Re: Response to TCEQ Comments  
Permit Modification Request – Changes to Final Cover Design to Include a Water Balance  
Alternative Final Cover  
Waste Management of Texas, Inc.  
Austin Community Recycling and Disposal Facility  
Travis County, Texas  
TCEQ Permit No. MSW 249D

**RE: RESPONSE TO TCEQ COMMENTS  
PERMIT MODIFICATION REQUEST  
WATER BALANCE ALTERNATIVE FINAL COVER  
AUSTIN COMMUNITY RECYCLING AND DISPOSAL FACILITY  
TRAVIS COUNTY, TEXAS  
TCEQ PERMIT NO. MSW-249D  
TRACKING NO. 22075131; RN100215938/CN600127856**

On behalf of Waste Management of Texas, Inc. (WMTX), Golder Associates Inc. (Golder) is submitting this response to comments for the above-referenced Permit Modification (PM) request to the existing Texas Commission on Environmental Quality (TCEQ) Permit Number Municipal Solid Waste (MSW) 249D, at the Austin Community Recycling and Disposal Facility, located in Travis County, Texas. The TCEQ provided these comments on the PM request in a notice of deficiency (NOD) letter dated December 19, 2017.

**FINAL COVER STABILITY – WATER BALANCE ALTERNATIVE FINAL COVER**

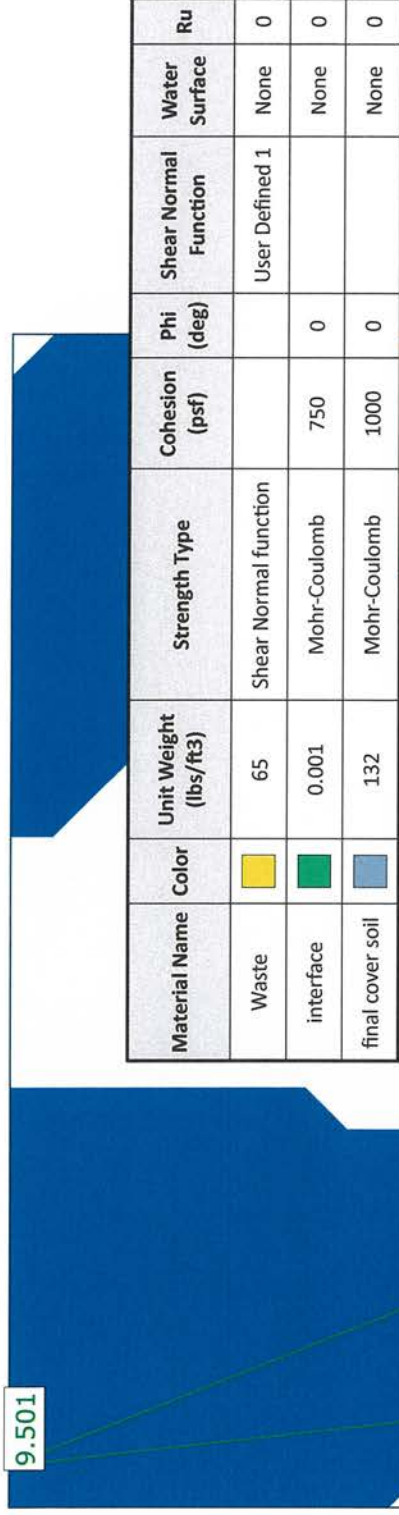
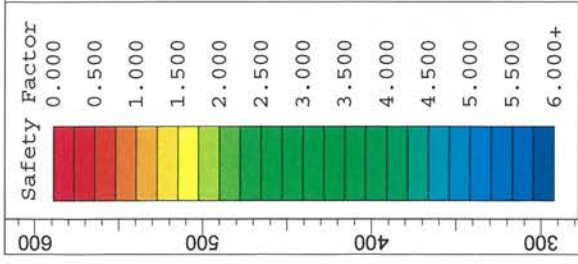
1. Comment: Clarify what the proposed alternative final cover layer thicknesses and properties are to be. The final cover stability analysis in proposed new Appendix C.5A indicates the infiltration layer will be four feet thick, and the erosion layer one foot thick, whereas the proposed revisions to the closure plan state the cover will consist of an 18-inch (minimum) infiltration layer and six-inch thick (minimum) erosion layer. The final cover quality control plan, in proposed new Section 5.0 (Alternative Water Balance Cover System) suggests that you still need to investigate the properties of the construction materials before you can specify the final design.

**Response: Part III, Attachment 3, Appendix C.5A has been revised to address material properties, to discuss the final cover profile, and to add a new circular failure mode analysis.**

**The equation used in the stability analysis was derived based on the force equilibrium of the final cover soil layer. Please refer to Chapter 12.3 of "Principles of Geotechnical Engineering" by Braja M. Das. This reference has been added to Part III, Attachment 3, Appendix C.5A, Section 3.0 (under Block Failure Mode).**

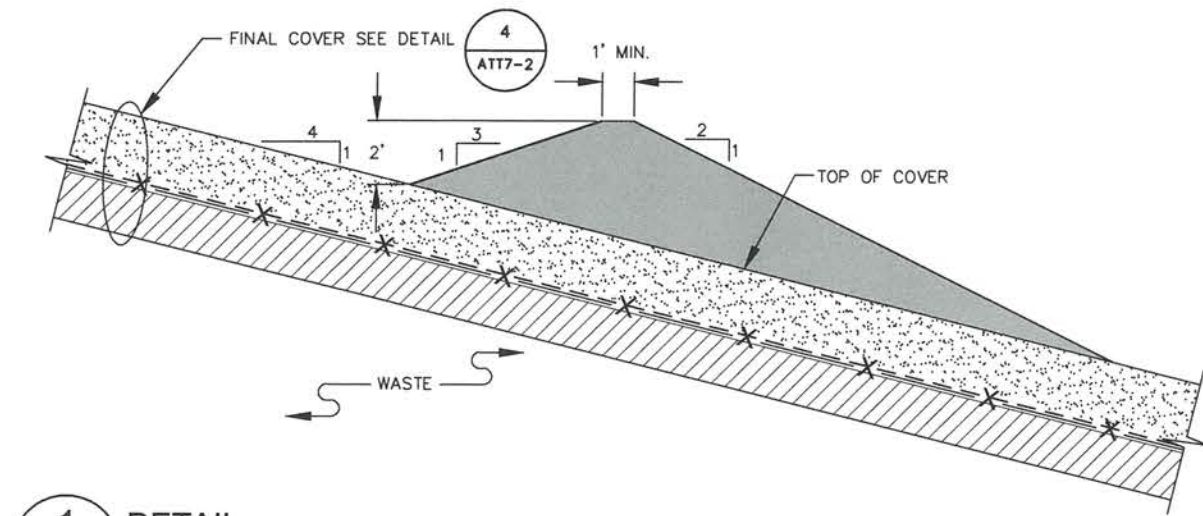
5. Comment: Provide marked copies of Figures ATT7-1A and ATT7-1B to show the proposed changes.

**Response: Marked copies of these figures have been added as requested.**

**4B** DETAIL  
ATT7-1 WATER BALANCE ALTERNATIVE FINAL COVER

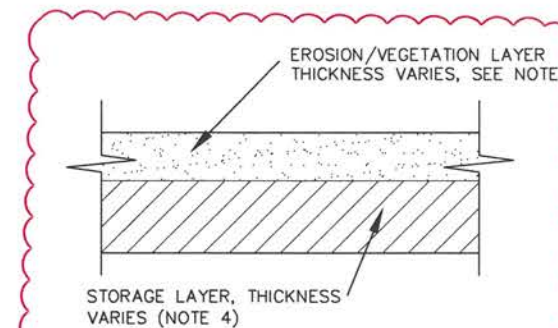
Three additional change were made. Part III, Attachment 7, Appendix A Section 5.3 was revised to show the proposed construction testing frequencies consistent with RG-494. Figure ATT7-1B was revised to more clearly show the West Hill expansion area. Figure ATT7-2 was revised to more clearly show the thickness of the erosion layer may vary.

The water balance final cover will be comprised of a storage layer of ~~18-20~~ inches thick (minimum) overlain by an erosion layer of 6 inches (minimum), in accordance with TCEQ Regulatory Guidance RG-494, Guidance for Requesting a Water Balance (WB) Alternative Final Cover for a Municipal Landfill, Revised March 2017. When using high plasticity clay (liquid limit >50) as the storage layer, the erosion layer will be increased to ~~one~~ 1-foot thick in accordance with Section 3 of RG-494. Hydraulic conductivity testing results of the storage layer soils may require a thicker storage layer in accordance with RG-494, as discussed in Appendix A, Section 5.2. The storage layer thickness ~~are-is~~ determined from Table 3 in Section 10 of the RG-494 as follows:
